Coal Valley Resources Inc. - Coal Valley Mine

**Robb Trend Project
Environmental Impact Assessment and Mine Permit Application
EPEA - 028-00011066; ERCB - 1725257**

Supplemental Information Request Responses

**Submitted to
Alberta Environment and Sustainable Resource Development and
the Energy Resources and Conservation Board**

PROJECT: Coal Valley Mine Robb Trend Project		
TITLE: Coal Leases		
DRAWN: PS	FIGURE:	
CHECKED: KY	7-1	
DATE: Nov 26/12		
PROJECT: 08-041

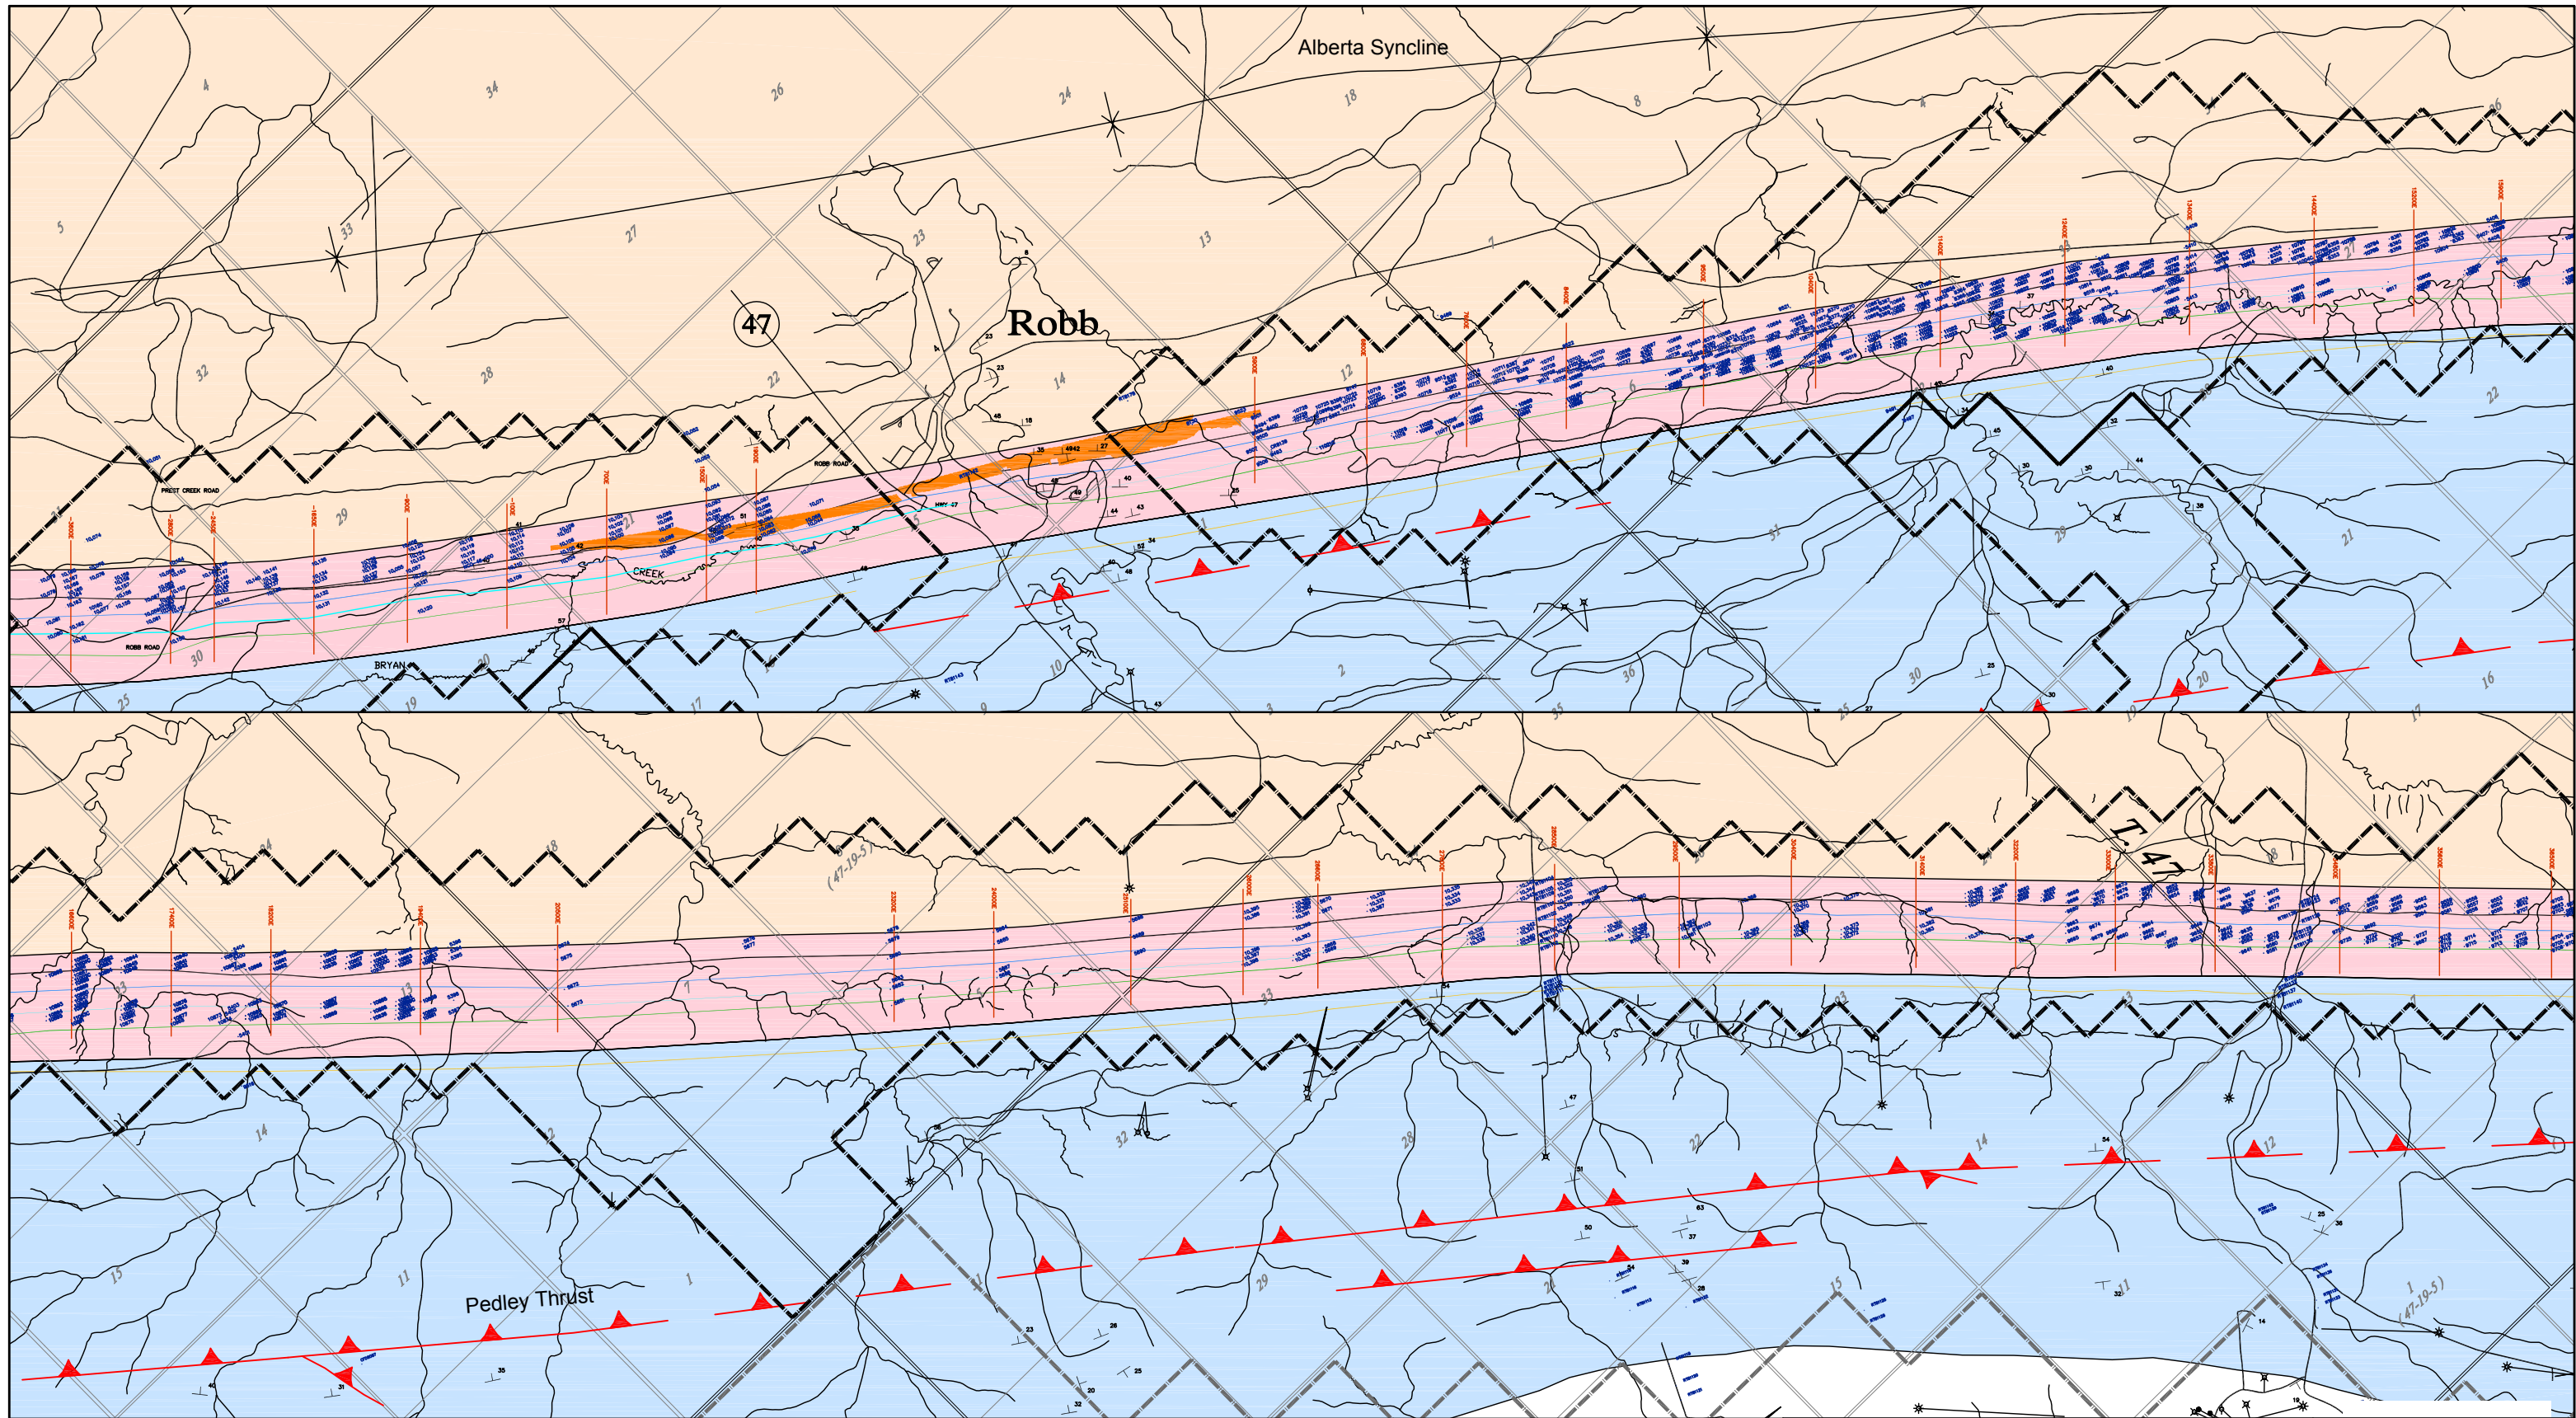
- b. Provide a revised Figure B.6-1 with all existing and proposed permits in the area and highlight the overlapping areas.

ERCB Figure 7-1 is provided to illustrate all existing and proposed mine permits in the Project area including the Robb West area. The ‘overlap’ area is highlighted.

DRAWN: JG	FIGURE:
CHECKED: KP	13-1
DATE: Dec 5/12	
PROJECT: 08-041

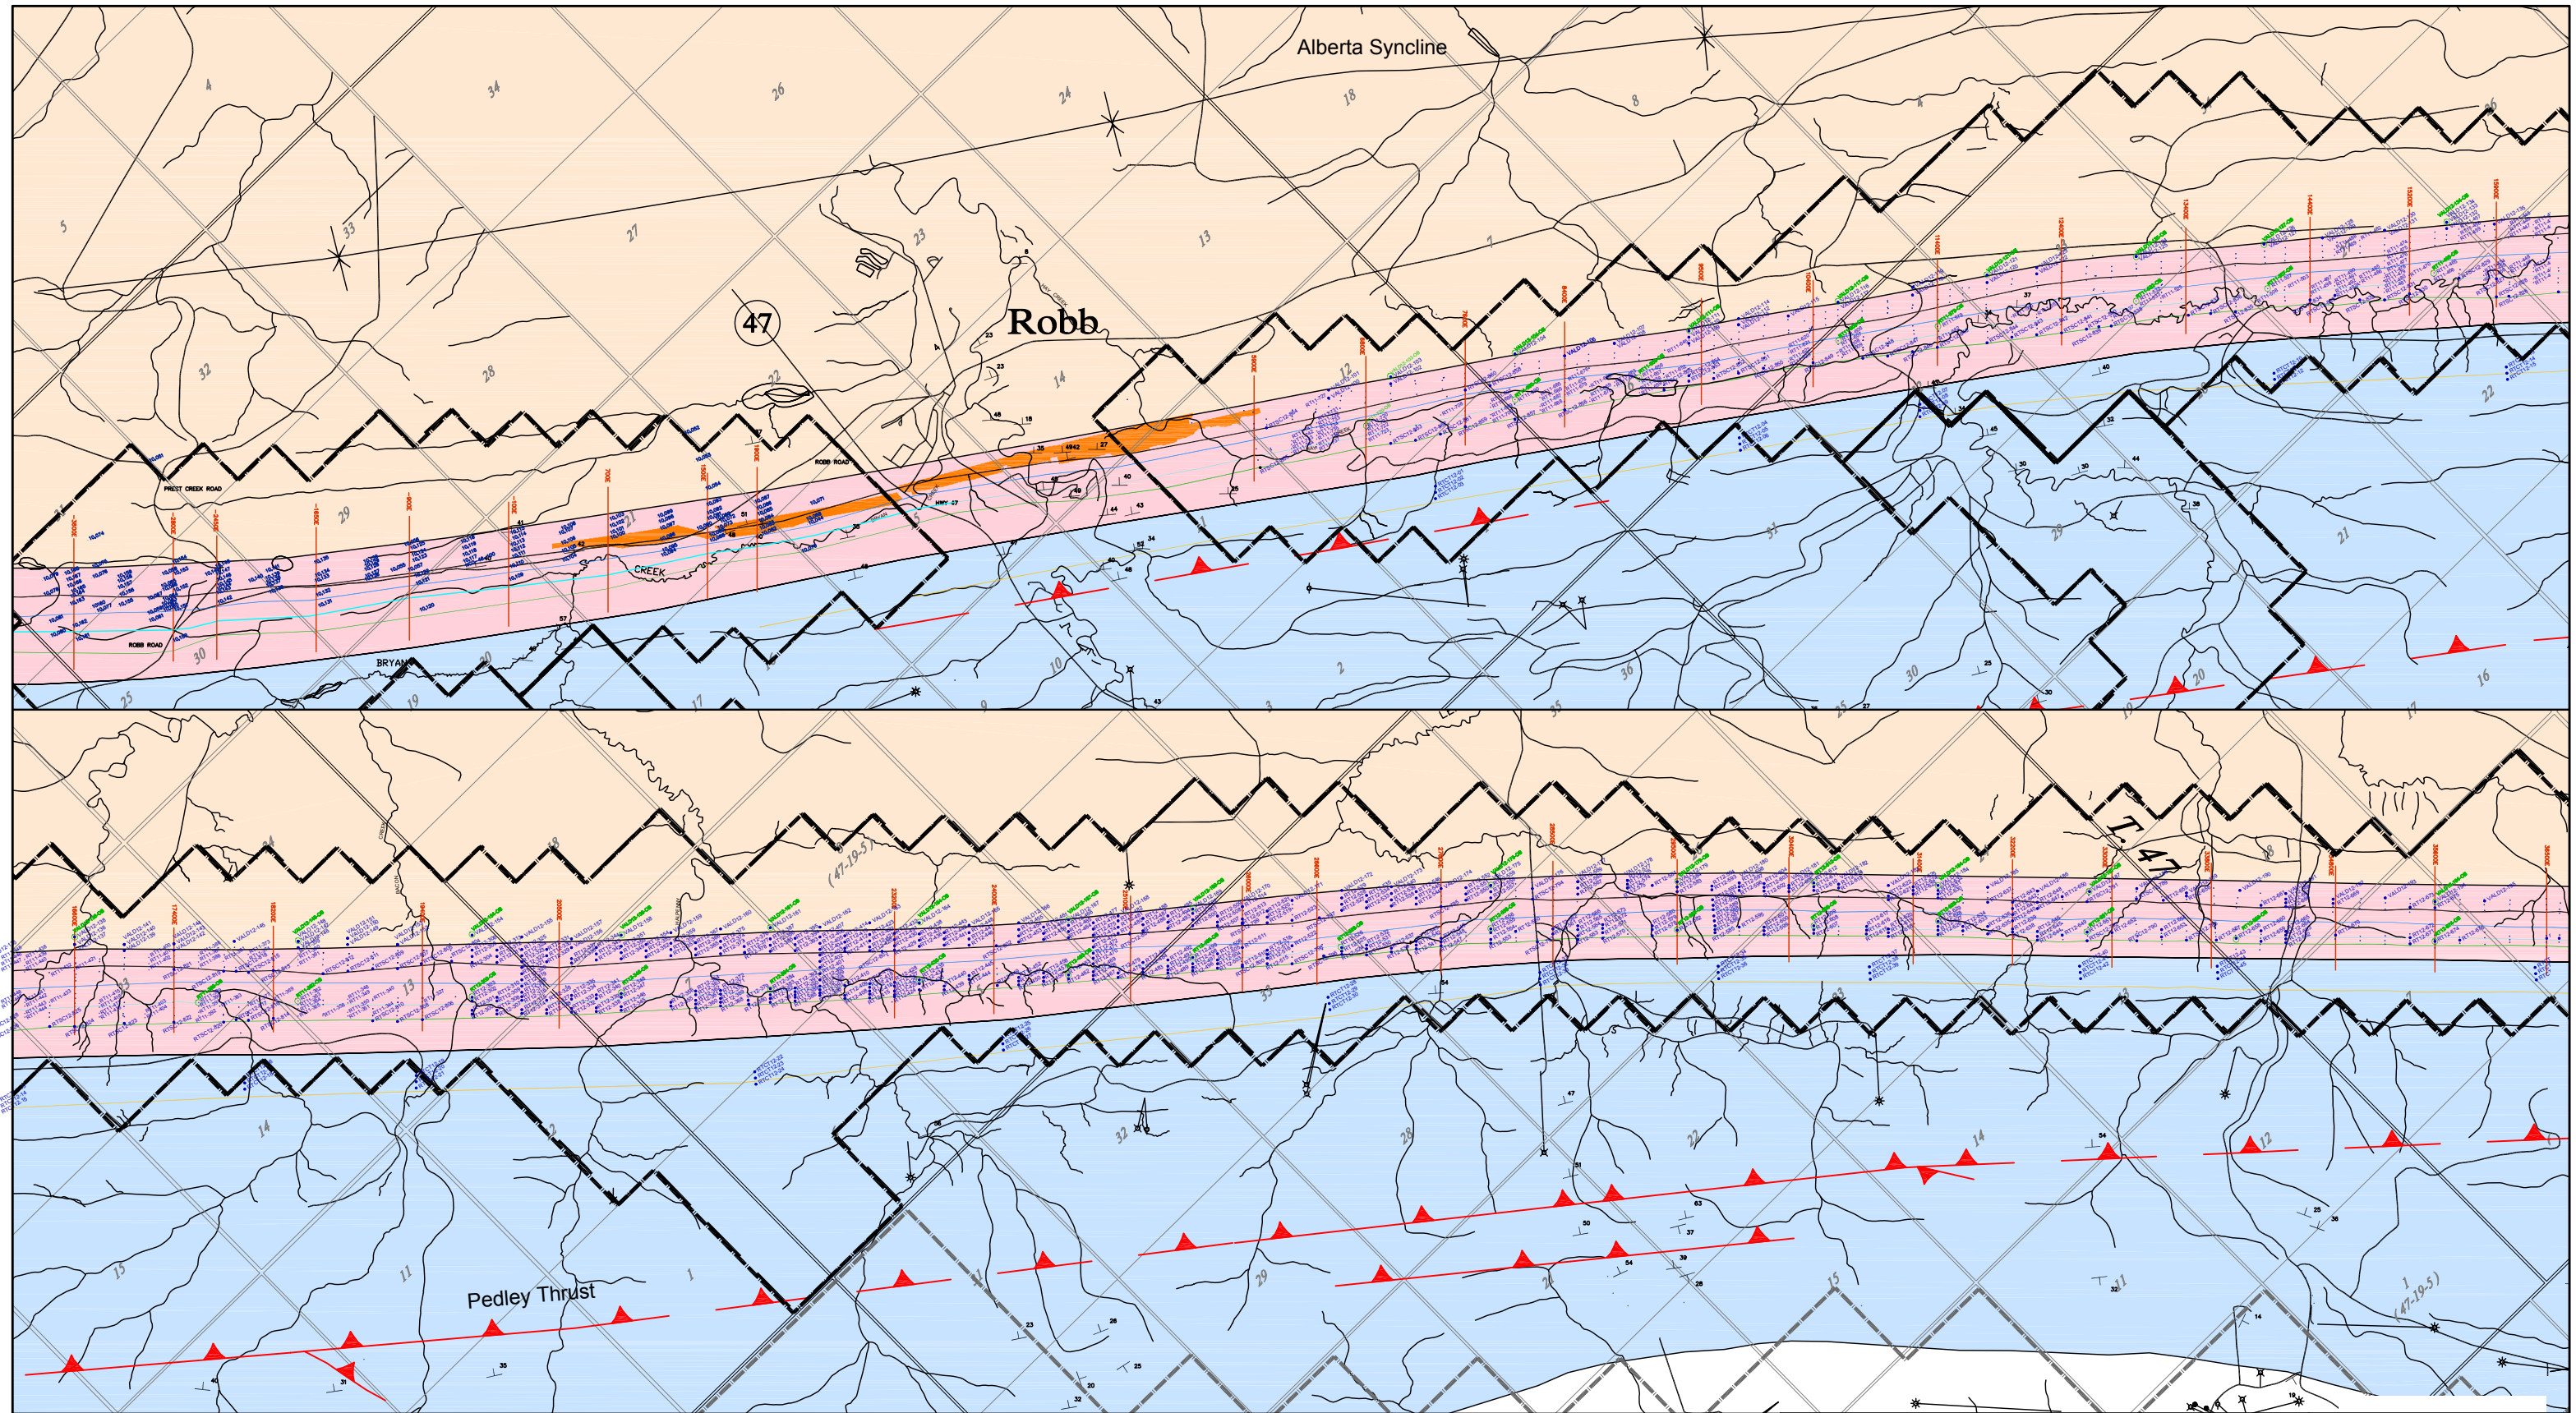
CVRI has not provided a plan showing drillhole locations within the application. However, MDH has submitted plans in Appendix 9, Figures A1 to A5 showing drillholes with additional geological information for parts of the proposed mine permit amendment.

A ‘revised drillhole plan’ is provided with the detail requested (See [ERCB Figure 13-1](#) and [ERCB Figure 13-2](#)). These figures include the completed drillholes and the proposed upcoming drillhole plan which is currently underway in the Project and will continue through 2013.

TITLE:
Outlines of LG Shells

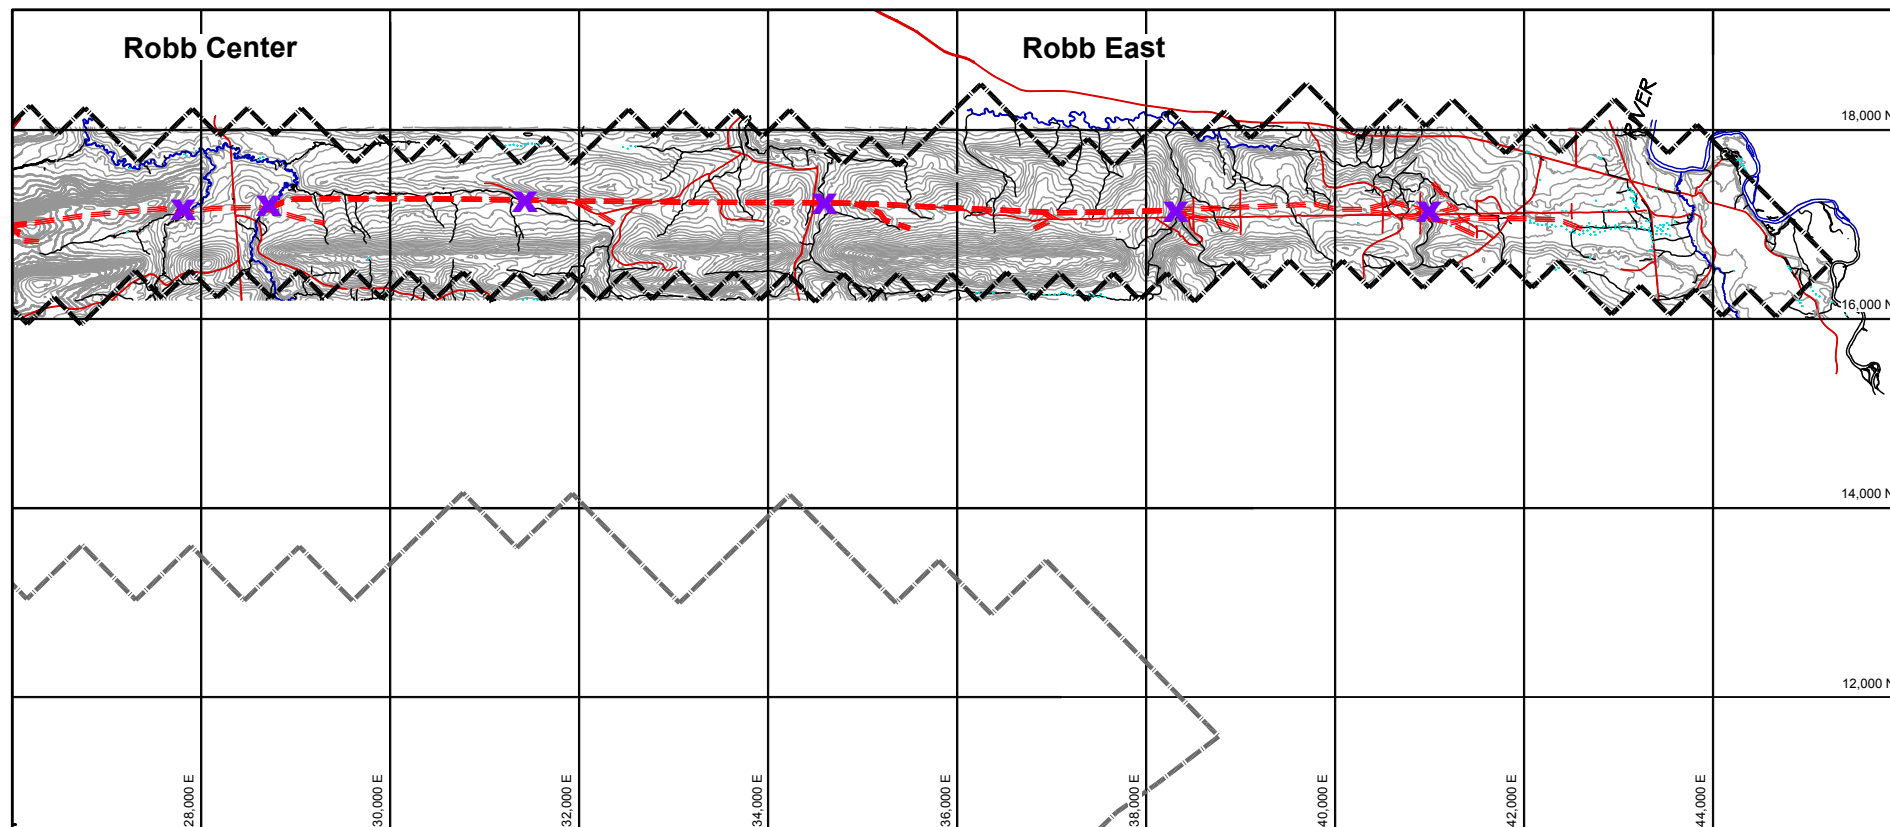
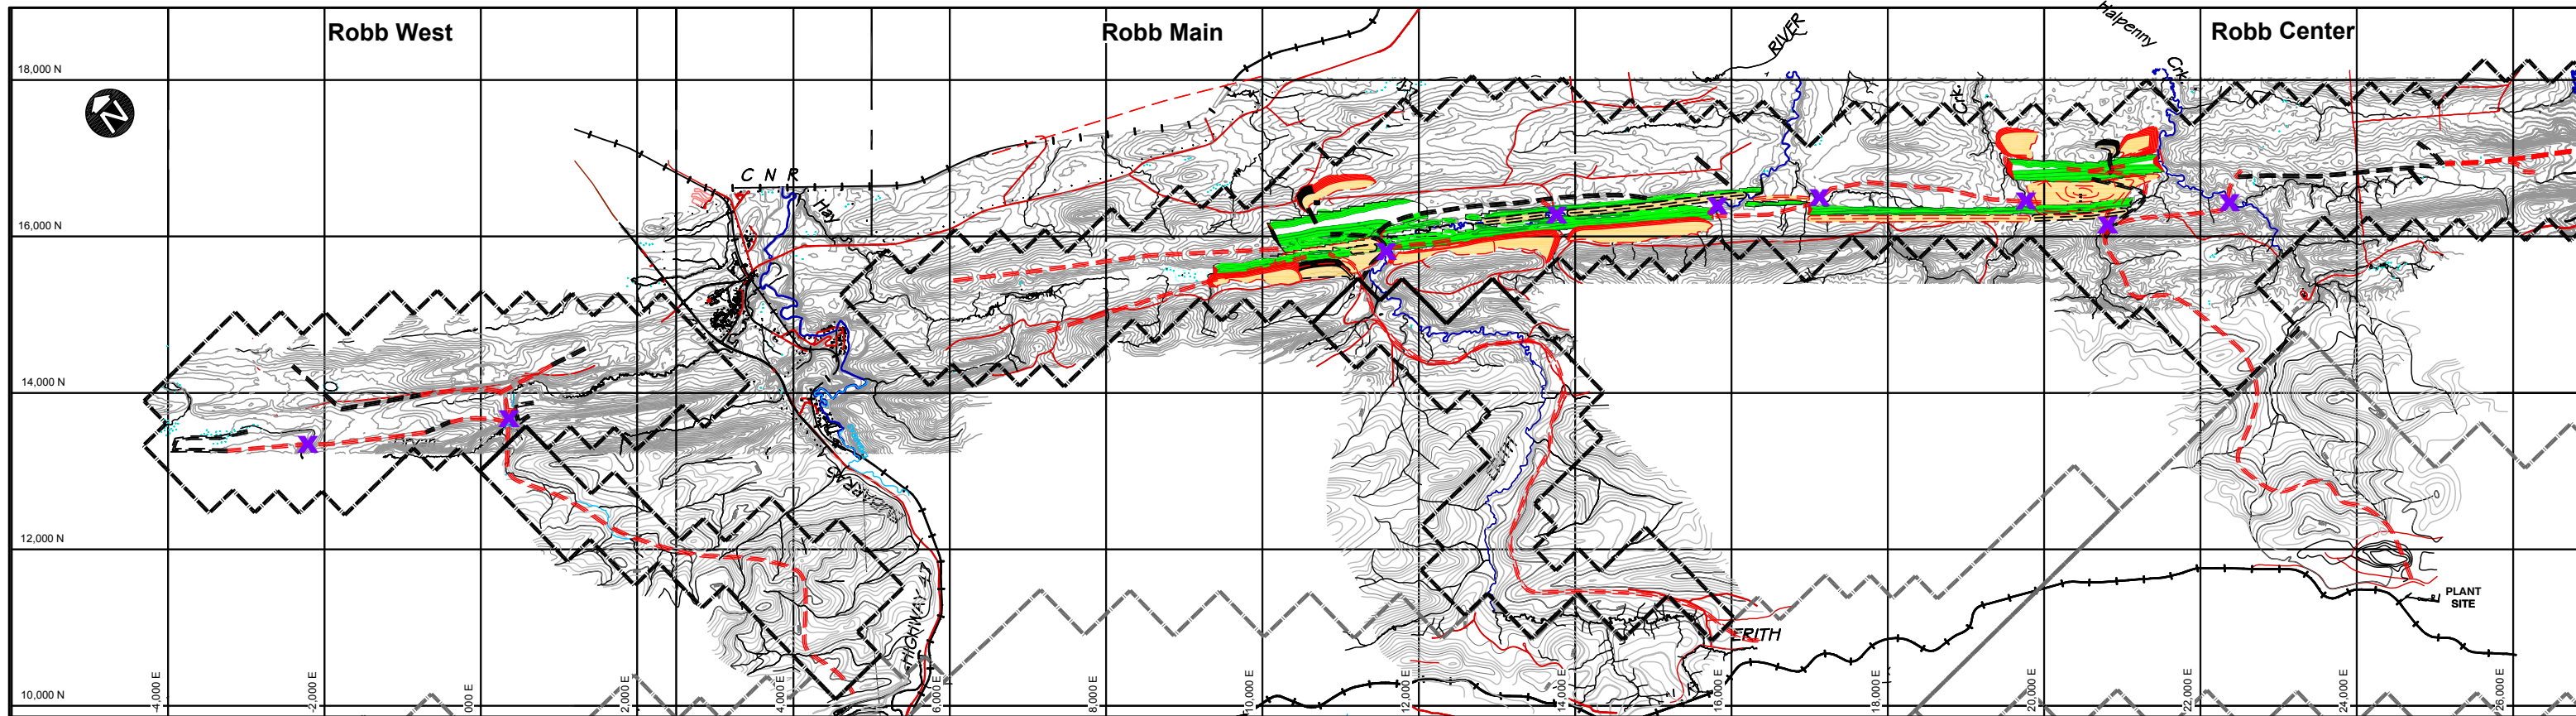
- a. Provide similar figures that show all BESR outlines for each pit location within the proposed permit amendment.

[ERCB Figure 28-1](#) is provided to illustrate the outlines of LG shells developed for the Project application. These shells are based on the inclusion of the Arbour Seam. Shells for ‘cut-off’ ratios of 4, 6 and 8 are illustrated.
